Cotton Dyeing & Finishing Mills Ltd. - Central Store shed.

17th January 2022

Central Store shed. (Shed-6): Single storied prefabricated steel shed.

Soil test report used in DEA report

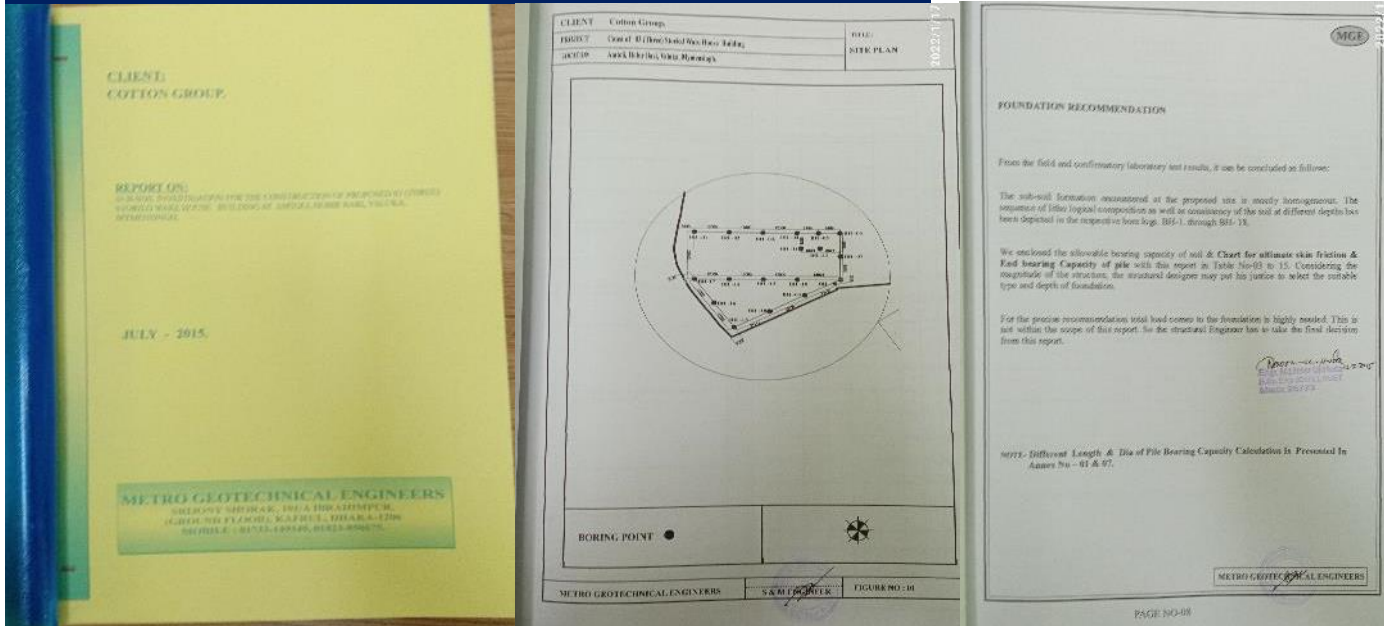
Soil bearing capacity consideration in DEA report & foundation adequacy check.

Geotechnical investigation report attached in the design report not matched with the available geotechnical investigation report. Consider geotechnical investigation report which was done close vicinity to the structure (Provided report during inspection), determine actual soil bearing capacity and check the foundation adequacy accordingly.

Mismatch in vertical bracing

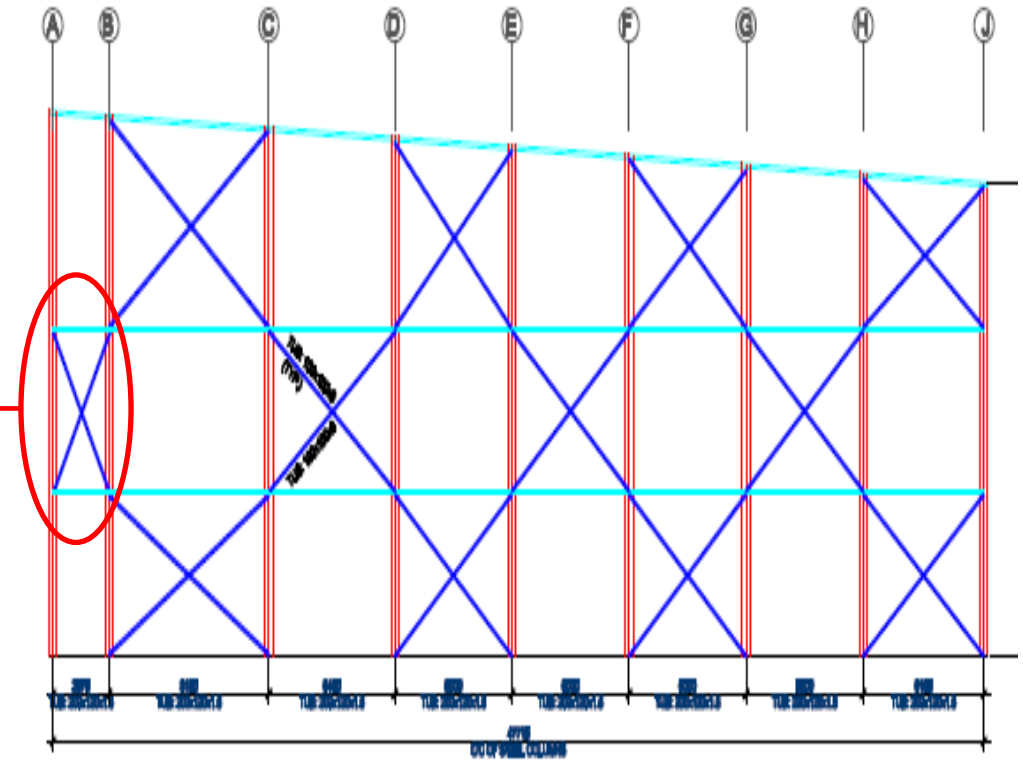
Discrepancies in as-built drawings & lack of details.

Column schedule, rafter schedule, compression strut details, some vertical bracing layout (Grid : 1-I to 15-O), steel stair details & some connection details are missing in steel part drawings. Mismatches were observed between drawings & existing condition. The building engineer is required to survey the structural components and produce accurate structural drawings.

Mismatch in column size

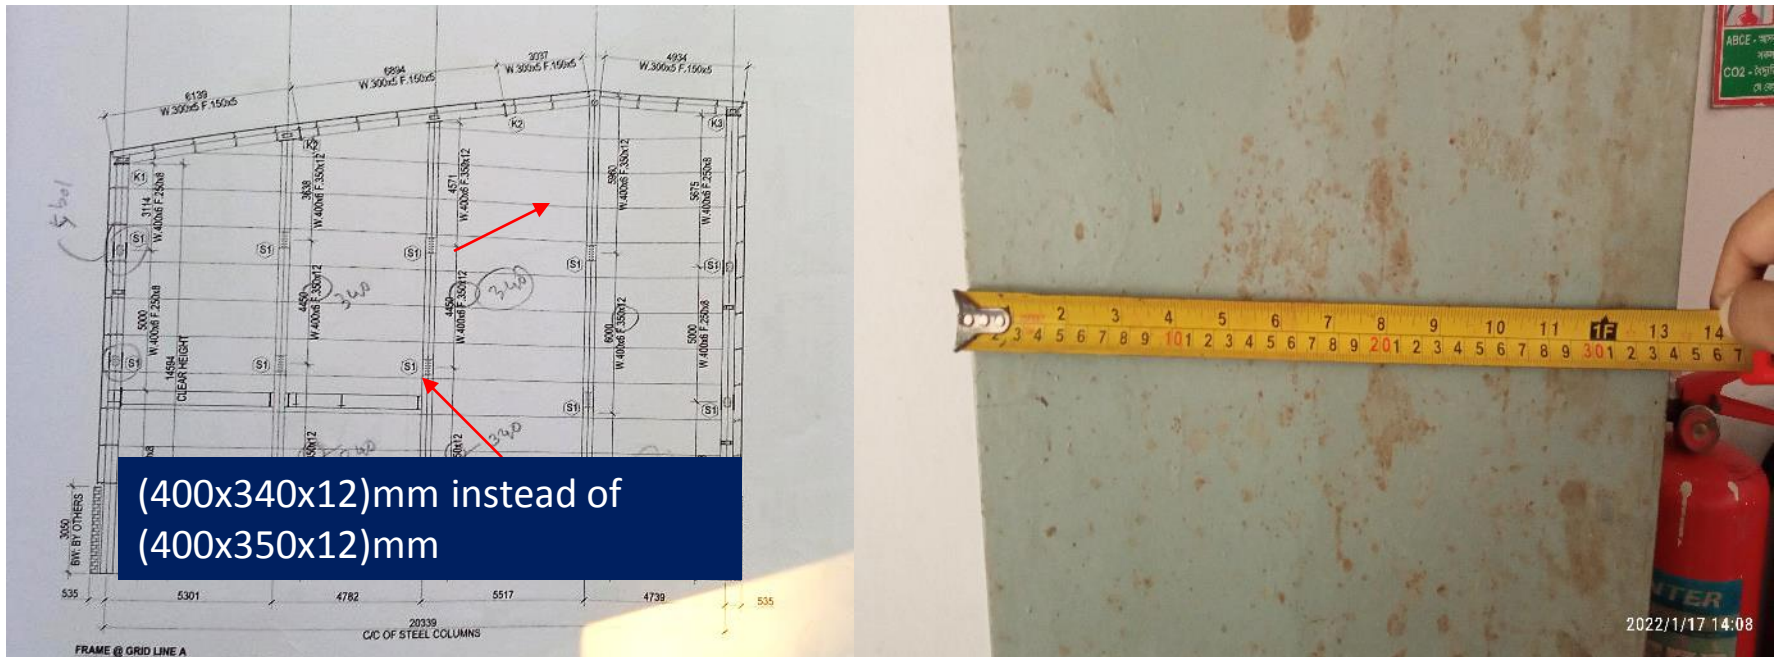
(400x340x12)mm instead of (400x350x12)mm
